ADDENDUM TO THE CONTRACT

CBJ HEADWORKS IMPROVEMENTS Contract No. BE17-033

ADDENDUM NO.: ONE

DATE ADDENDUM ISSUED: December 1, 2016

PROJECT 4029/21157/01
 DATE 10/24/2016
 SHEET 46 OF 61
JA-05

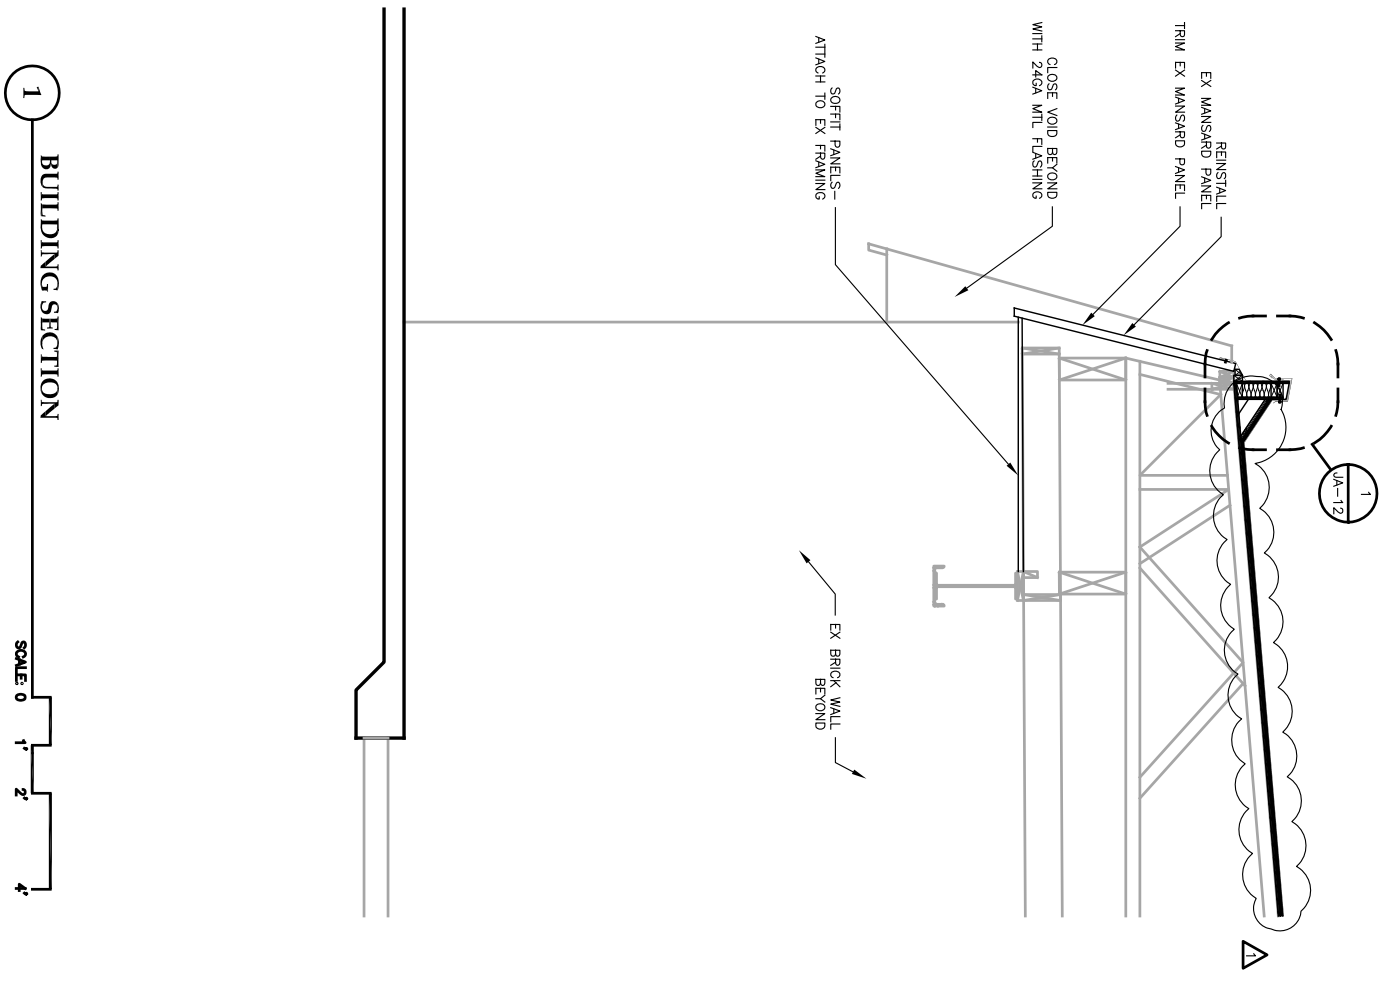
- Item No. 21: PLAN SHEET JA-05, DOOR AND RELITE SCHEDULE. **Add** the following note:
 “Provide Hardware Set 1 described in SECTION 087100 – DOOR HARDWARE at door 101. All hardware for door 102 to be provided by Coiling Door manufacturer as described in SECTION 083323 – OVERHEAD COILING DOORS”.

CBJ HEADWORKS IMPROVEMENTS
CONTRACT No. BE17-033
JUNEAU DOUGLAS ARCHITECTURAL
EXTERIOR DETAILS
PROJECT 4029/21157/01
DATE 10/24/2016
SHEET 53 OF 61
JA-12

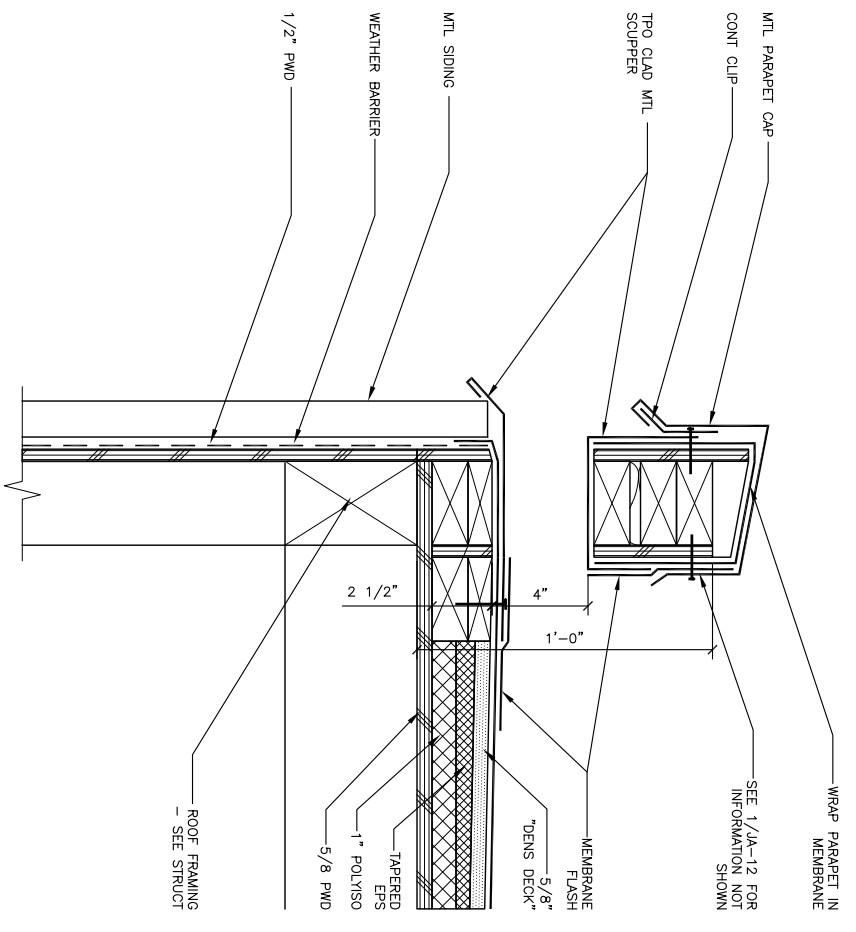
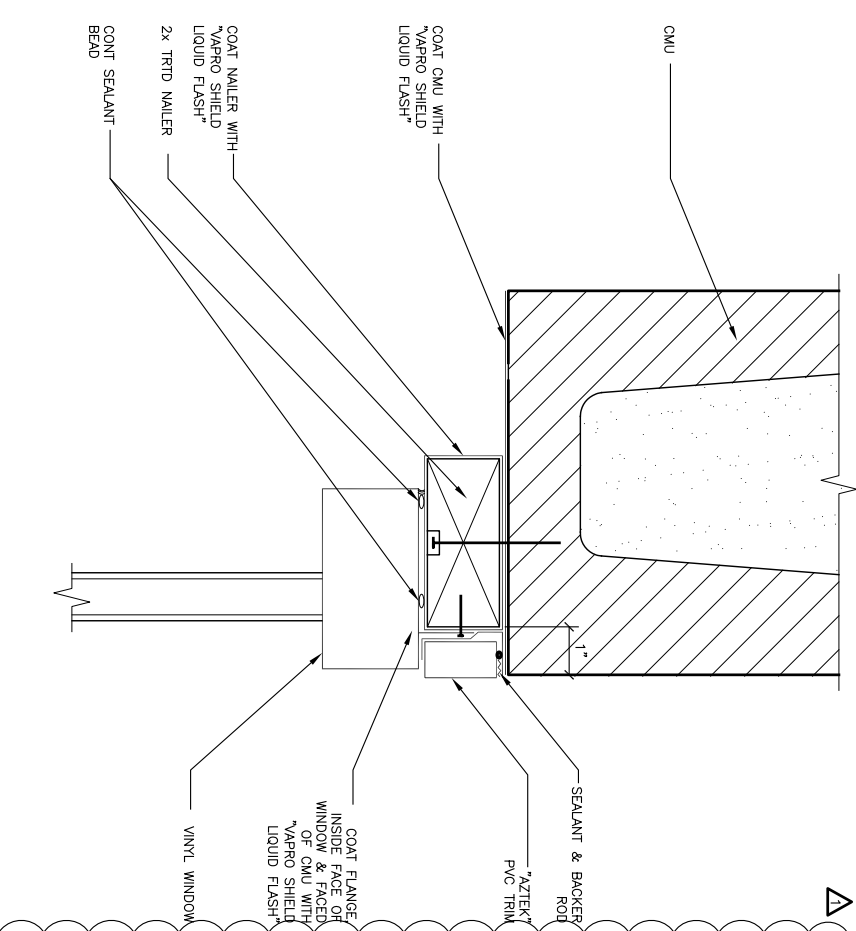
Item No. 27: PLAN SHEET JA-12: Add the following note to details 3 and 4: "Scuppers to be 8" wide".
